HISTORIC AND DESIGN REVIEW COMMISSION

April 03, 2024

HDRC CASE NO: 2024-126
ADDRESS: 232 CAMARGO
LEGAL DESCRIPTION: NCB 924 BLK 5 LOT N 109.77 FT OF 7 & N 109.77 FT OF E 6 FT OF 6
ZONING: RM-4, H
CITY COUNCIL DIST.: 1
DISTRICT: Lavaca Historic District
APPLICANT: Fernando Morales | Candid Works PLLC
OWNER: Angela Lombardi
TYPE OF WORK: Front and side yard fence construction
APPLICATION RECEIVED: March 15, 2024
60-DAY REVIEW: May 14, 2024
CASE MANAGER: Bryan Morales

The applicant is requesting a Certificate of Appropriateness for approval to replace the existing chain link fence along the north and east portions of the property with a steel framed cattle-panel fence.

1 FENCE PLAN

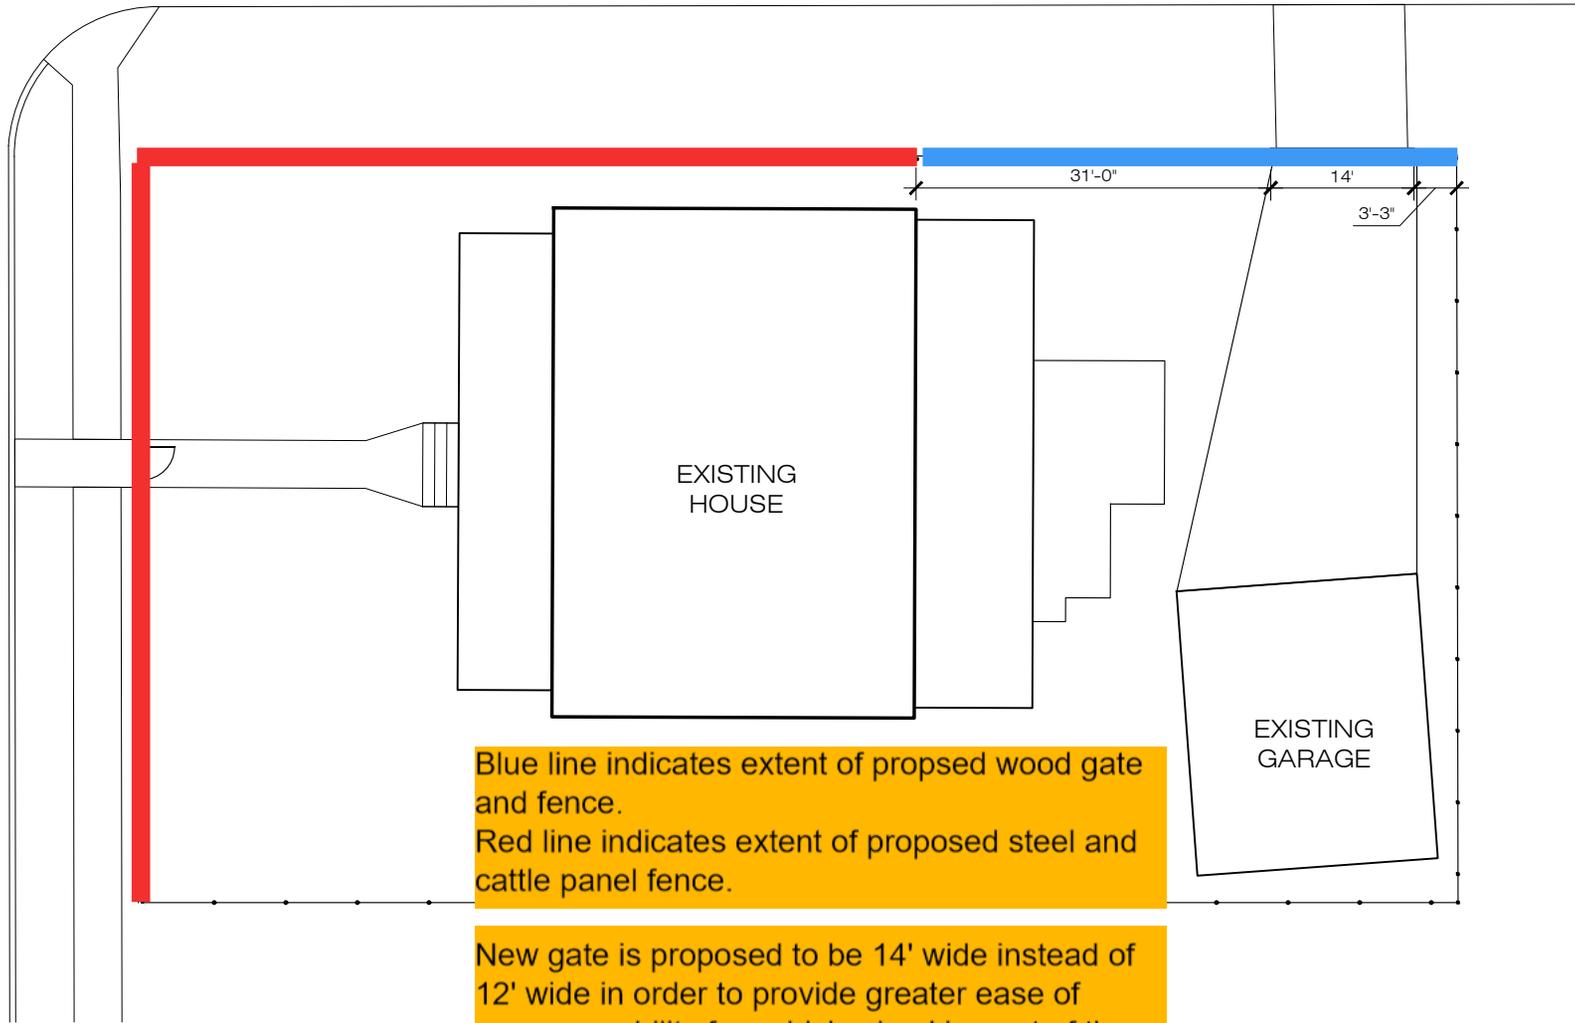
- e. FENCE INSTALLATION (NORTH) – The applicant is requesting approval to replace the existing chain link fence with a four and a half feet tall steel framed cattle-panel fence. The Historic Design Guidelines for Site Elements 2.B.i. states new fences and walls should appear similar to those used historically within the district in terms of their scale, transparency, and character and the design of the fence should respond to the design and materials of the house or main structure. Site Elements 2.B.v. states to construct new fences or walls of materials similar to fence materials historically used in the district and to select materials that are similar in scale, texture, color, and form as those historically used in the district, and that are compatible with the main structure. Staff finds the replacement of the chain link fence appropriate; however, the replacement fence should use a design and materials found within the Lavaca historic district.

- f. FENCE INSTALLATION (EAST) – The applicant is requesting approval to replace a portion of the existing chain link fence at the east with a four and a half feet tall steel framed cattle-panel fence. Site Elements 2.B.i. states new fences and walls should appear similar to those used historically within the district in terms of their scale, transparency, and character and the design of the fence should respond to the design and materials of the house or main structure. Site Elements 2.B.v. states to construct new fences or walls of materials similar to fence materials historically used in the district and to select materials that are similar in scale, texture, color, and form as those historically used in the district, and that are compatible with the main structure. Staff finds the replacement of the chain link fence appropriate; however, the replacement fence should use a design and materials found within the Lavaca historic district.

- i. That the applicant install a front yard cattle-panel fence to not exceed four feet in height and feature wood framing.
- ii. That the applicant install a side yard cattle-panel fence to not exceed six feet in height, feature wood framing, and placed behind the front façade of the primary structure.
